Z-48  
(2014)

**ZONING PLAN FOR:**  
DAVID PEARSON COMMUNITIES  
PROPERTY IS LOCATED IN LAND LOT 629 & 630  
IN THE 16TH DISTRICT, 2ND SECTION  
COBB COUNTY, GEORGIA  
SCALE: 1" = 50'. DATE: APRIL 21, 2014

**ZONING COMMENTS:**

Applicant is requesting the Fee Simple Townhouse (FST) zoning category for the development of an 11-lot detached townhome community. The proposed detached townhomes will be traditional in architecture and the minimum unit size will be 2,000 square feet. The architectural features will be combinations of brick, stone, cedar shake and hardyplank. The proposed townhomes will range from \$300,000s and greater.

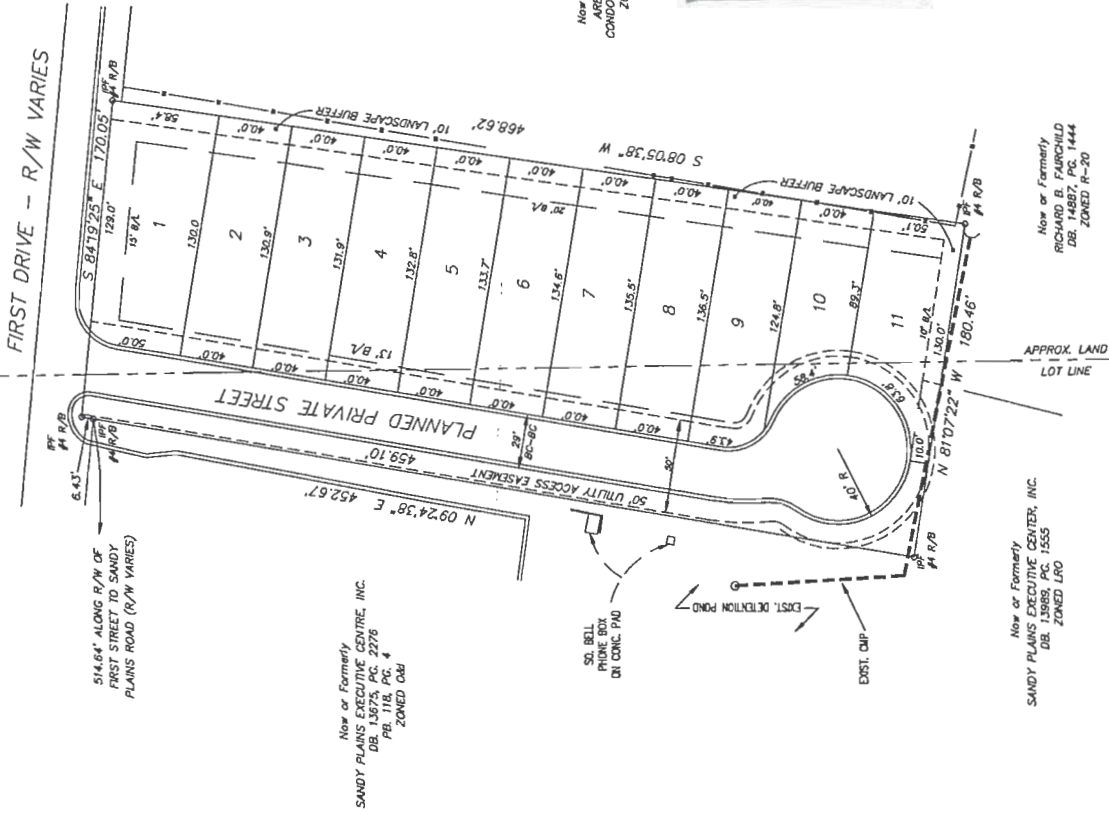
The site plan indicates a private street is planned and the applicant requests that the setbacks for the development be geared toward the private street, instead of First Drive. This will require granting a waiver of the front setback along the private street from 25 feet to 13 feet; waiving the rear setback abutting the eastern property line from 35 feet to 20 feet.

When projects contemplate less than 20 foot separation between units, guest parking shall be provided or the streets shall be labeled as a fire lane.

Additional Comments: Master meter to be set at public ROW

Additional Sewer to be private in private street  
Comments:

1. This site is located on First Drive between Sandy Plains Executive Center to the west and the Arbor Oaks Suburban Condominium development to the east. The entire site drains to the east through the Arbor Oaks development. With the proposed layout a drainage easement will be required along the rear of all the lots to adequately control runoff from the site. Since it appears that underground detention will be utilized under the private street, it may be necessary to relocate the street to the low-side of the site, adjacent to Arbor Oaks, to adequately control site runoff.

2. The detention pond for the adjacent Sandy Plains Executive Center discharges through an existing pipe along the southern boundary of this site. An adequate drainage easement must be provided for this conveyance.

3. Since private streets are proposed all stormwater management within the development including the detention facility will be privately maintained in perpetuity by the HOA.

First Drive is classified as a local and according to the available information the existing right-of-way does not meet the minimum requirements for this classification.

Recommend applicant consider entering into a development agreement pursuant to O.C.G.A. 36-71-13 for dedication of the following system improvements to mitigate traffic concerns: a) donation of right-of-way on the south side of First Drive, a minimum of 25' from the roadway centerline.

Recommend curb, gutter, and sidewalk along the First Drive frontage.

Recommend private streets be constructed to the Cobb County Standard Specifications.

**REZONING PLAN FOR:**  
**PEARSON COMMUNITIES**

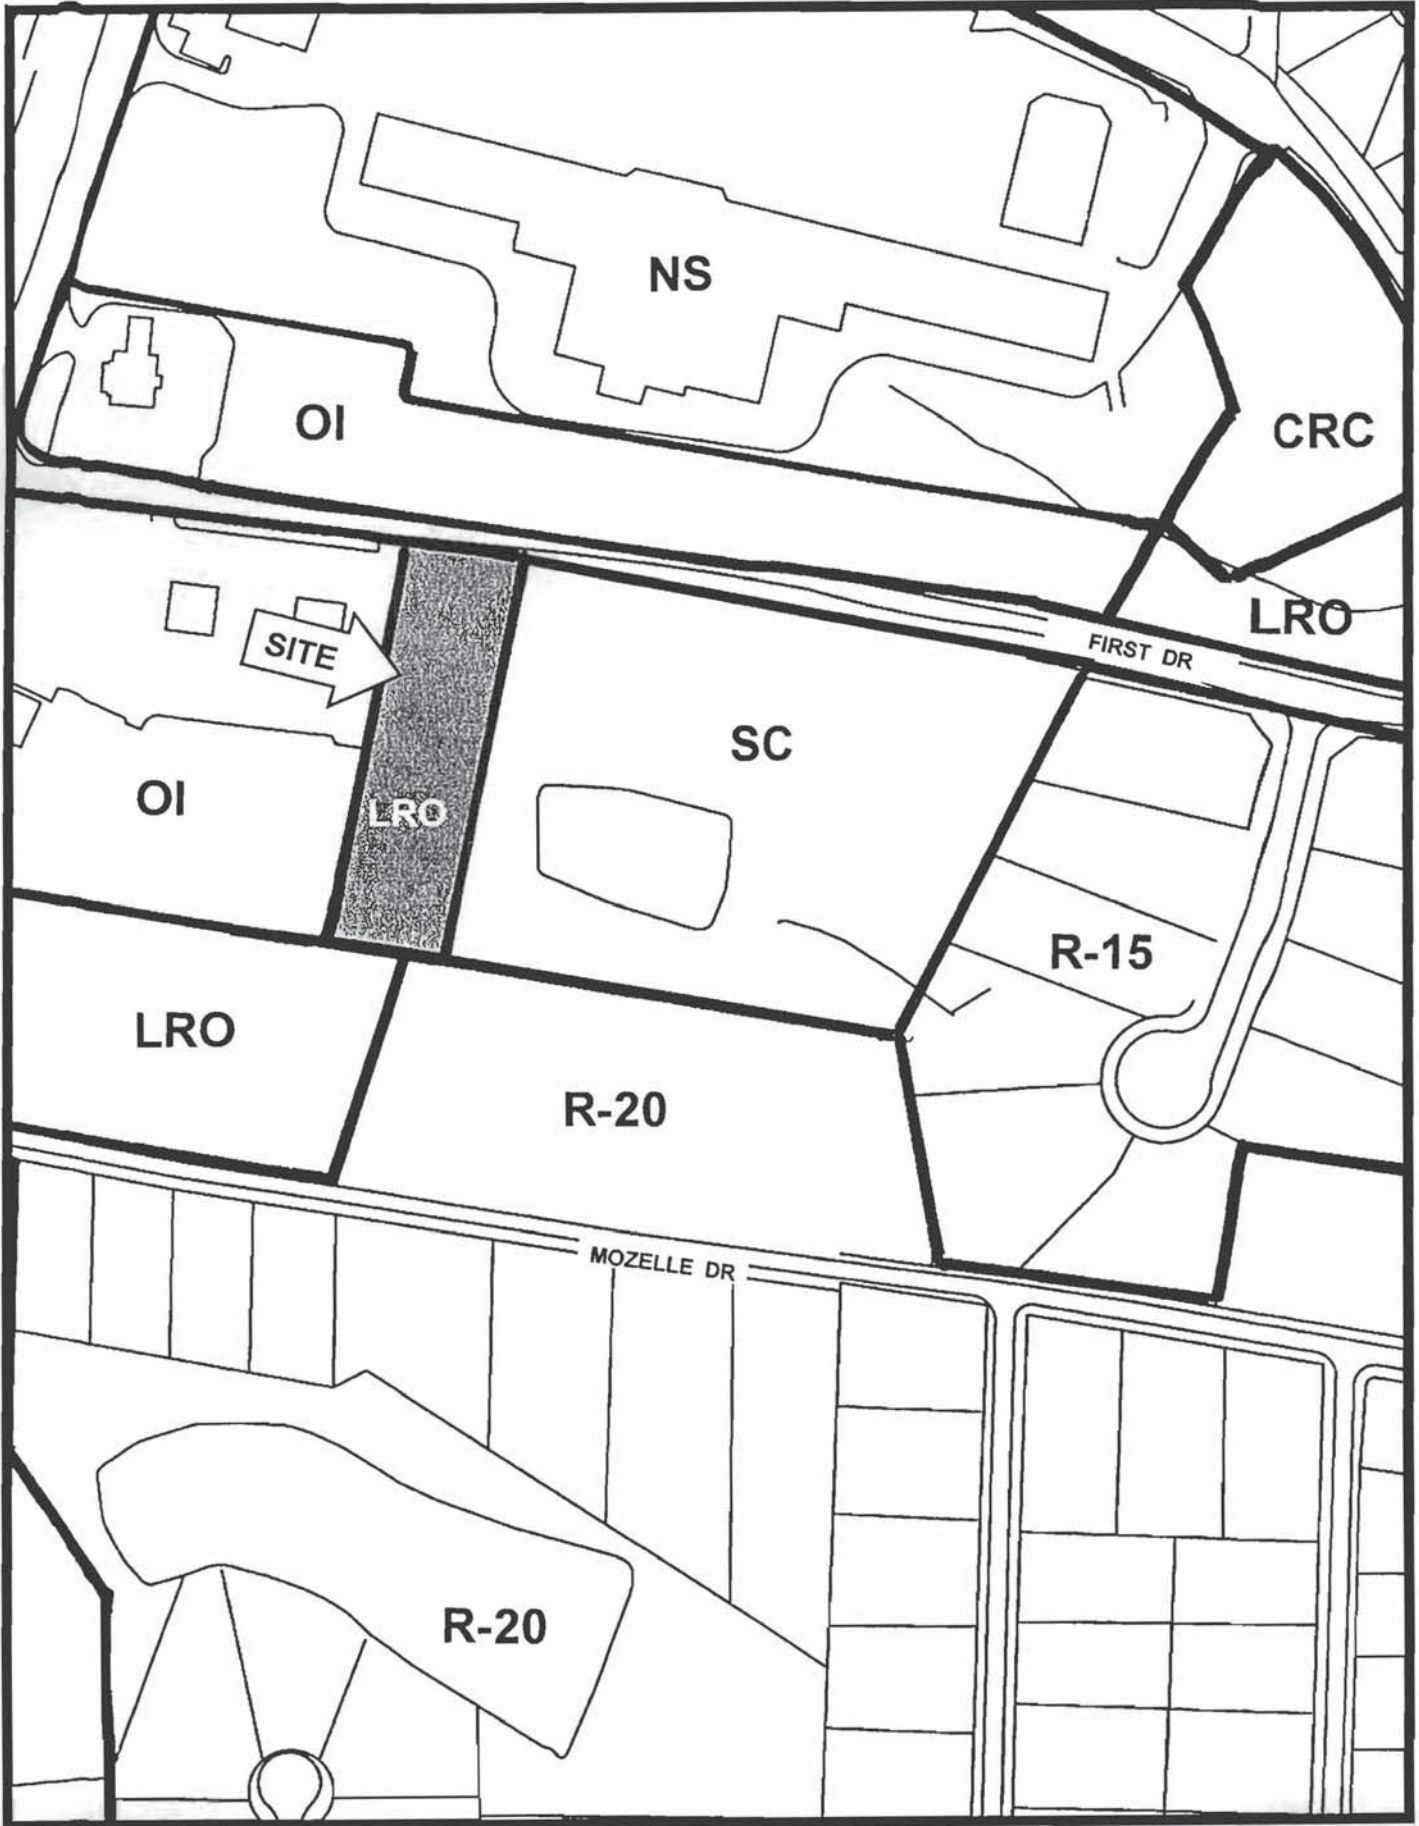
The applicant is requesting the OI zoning category to develop a three-story office building on this property. The building will be traditional in styling, with a facade of brick and stone. The building will be used for general and professional offices. The previous rezoning stipulations are attached for review (see Exhibit "A"). It should be noted here that there is a 20-foot buffer required adjacent to residentially zoned property, which is not shown, and the required parking is not being met.

Also, sewer at or near W property line

- Natural slope of tract is to general area of proposed detention. Historically, flow crossed into next property as sheet flow along Eastern boundary. At Plan Review discharges must conform to historical. No concentrated flow channel exists on adjacent property.
- This design is very impervious intensive and will load the downstream system to a greater level than now---downstream are tandem detention ponds---upstream from this project is a major detention pond. At Plan Review, the designer of this project must route the entire system before and after to demonstrate no worse condition than now exists.

First Drive is classified as a Non-residential Local and according to the available information, the existing right-of-way does meet the minimum requirements for this classification.

Install sidewalk, curb, gutter and drainage structures.

An FAA study is required for all structures 4 stories and greater.
